U.S. Department
of Transportation
**Federal Highway
Administration**

In reply to: HSSD/WZ-277

In your letter of January 29 you requested the Federal Highway Administration (FHWA) acceptance of the modified and re-designed Multi Barrier Model MB 42 x 72 JSS longitudinal channelizing device as a crashworthy traffic control devices for use in work zones on the National Highway System (NHS). Accompanying your letter was the FHWA Office of Safety Design form, a drawing of the device, and a detailed description of previous testing you completed on a similar longitudinal channelizing device (WZ-255). The drawing and detailed description are enclosed with the acceptance form for the re-designed Multi Barrier Model MB 42 x 72 JSS longitudinal channelizing device. The re-designed device is intended for use with no more than 41 liters (10.8 gallons) of water in each module as ballast. You requested that we find this device acceptable for use on the NHS under the provisions of the National Cooperative Highway Research Program Report 350, "Recommended Procedures for the Safety Performance Evaluation of Highway Features".

WZ-277 Attachment #1: Description and discussion of modification to cra

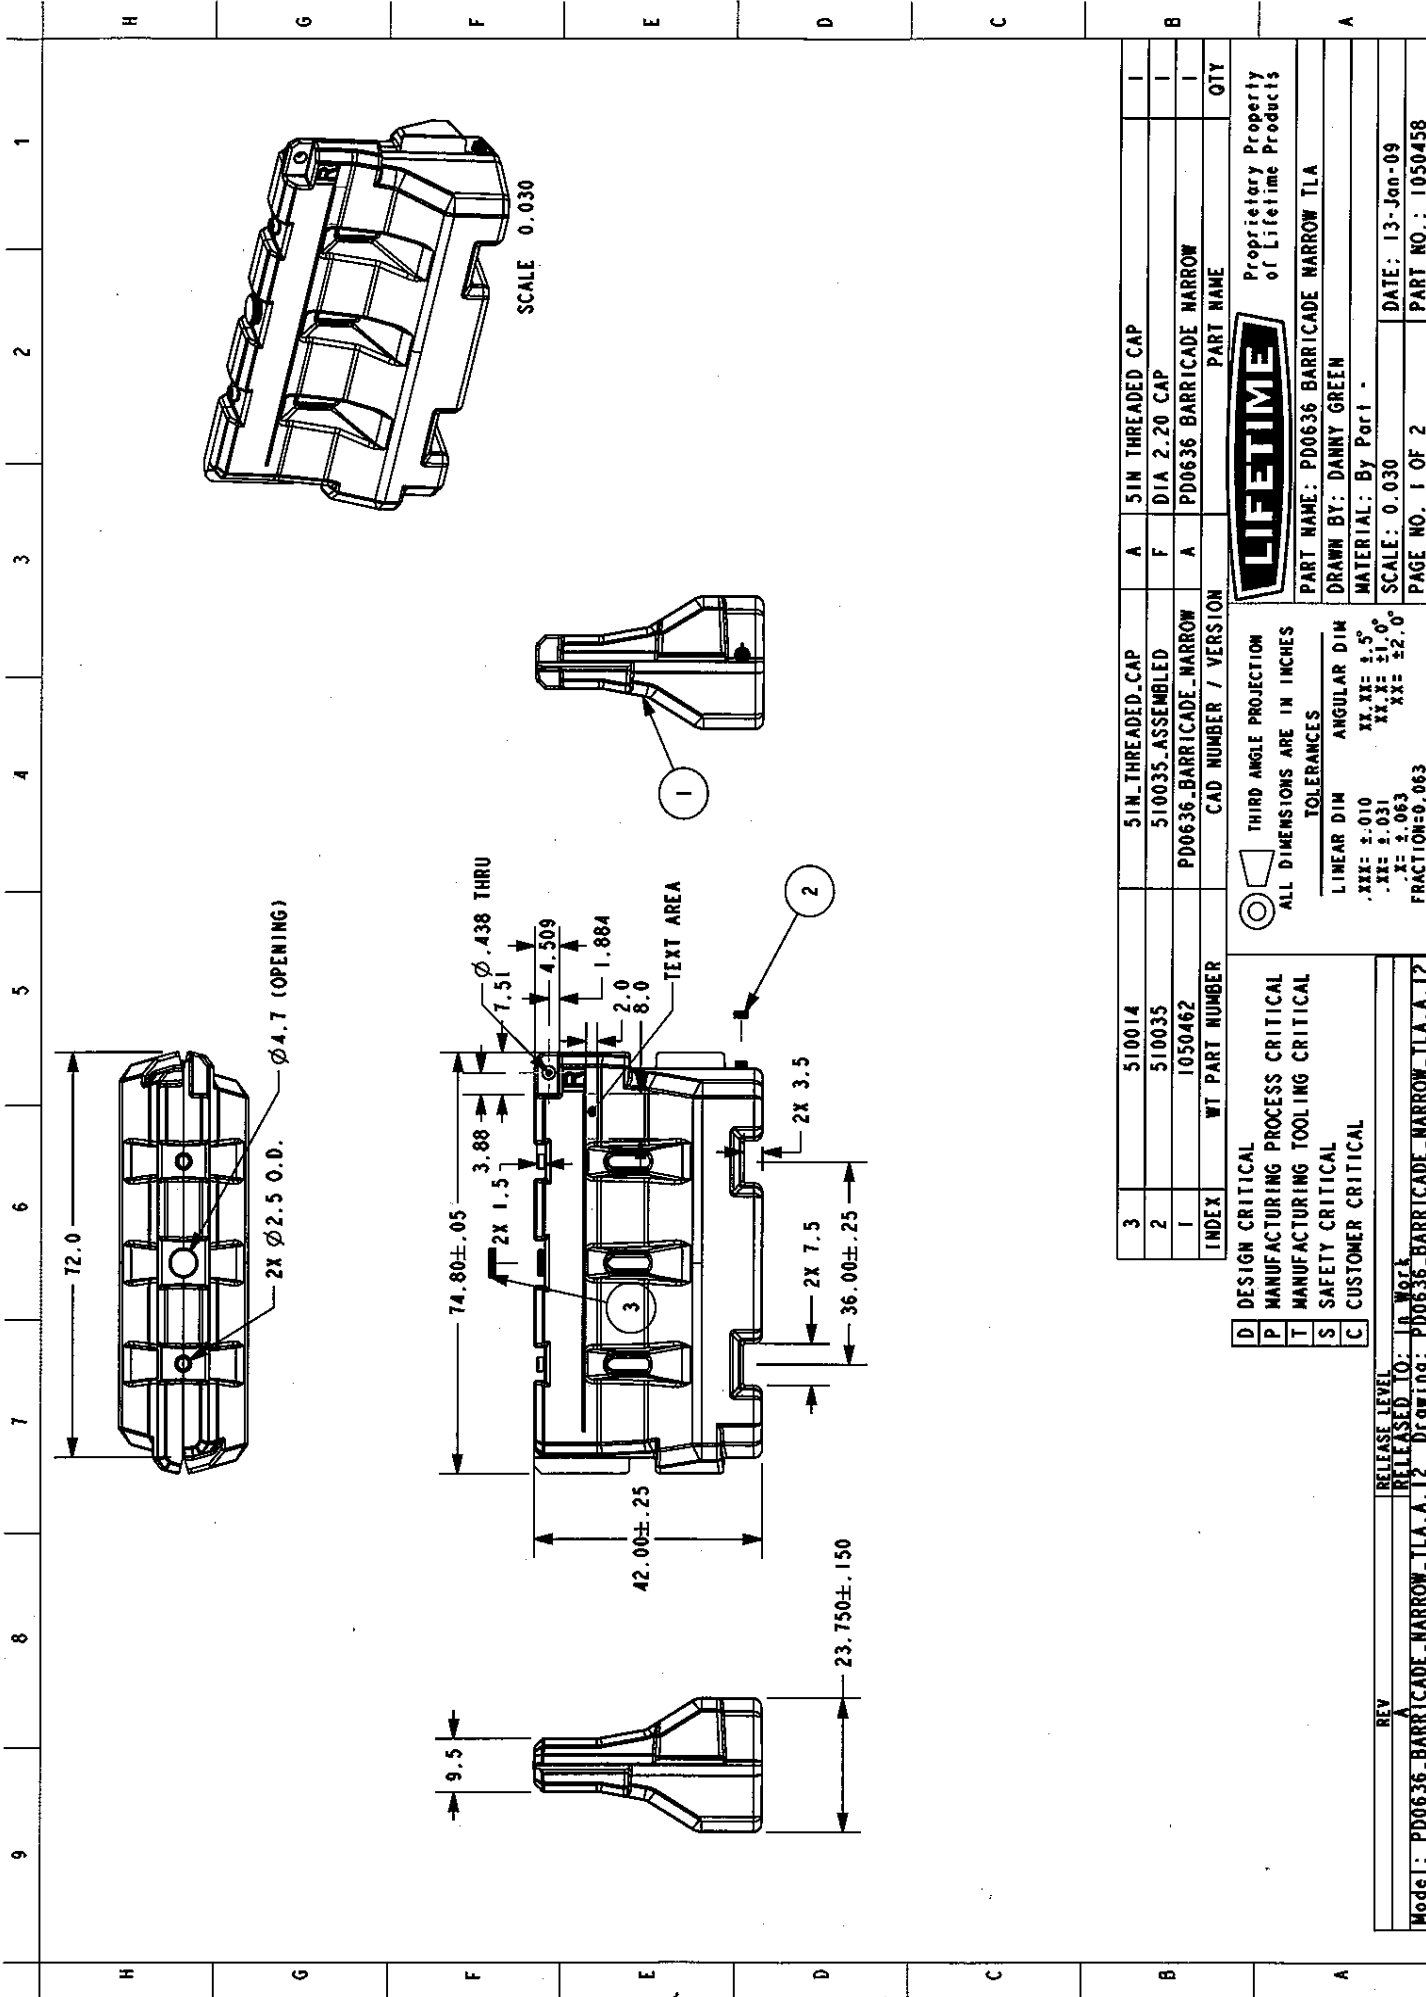
The tested LCB Model MB42x72 JSS LCB is 2 interconnected pieces, 42 high, 35 1/2 long, and 24 wide, for a total tested dimension of 42 high, 72 long, and 24 wide. The modified unit is one piece 72 long, 42 high, and 24 wide. We have eliminated the dog bone connection device in lieu of a one piece design. Essentially the weights and dims are the same. The water weight on the tested unit is poured into two chambers. The new unit is one single chamber with the same volume. The only difference is the connection.

We have eliminated the pin and doughnut connection as it will not come apart easily when lifted from the bottom in the back of a truck or in a work zone. The pin actually causes the water cell to rupture when lifted from the end. We have gone back to the same locating system we have used on the MB42x45 LCB (WZ-214). This system cannot actually lock together, either intentionally or unintentionally, so has the added benefit of gating without the possibility of locking when struck by a vehicle.
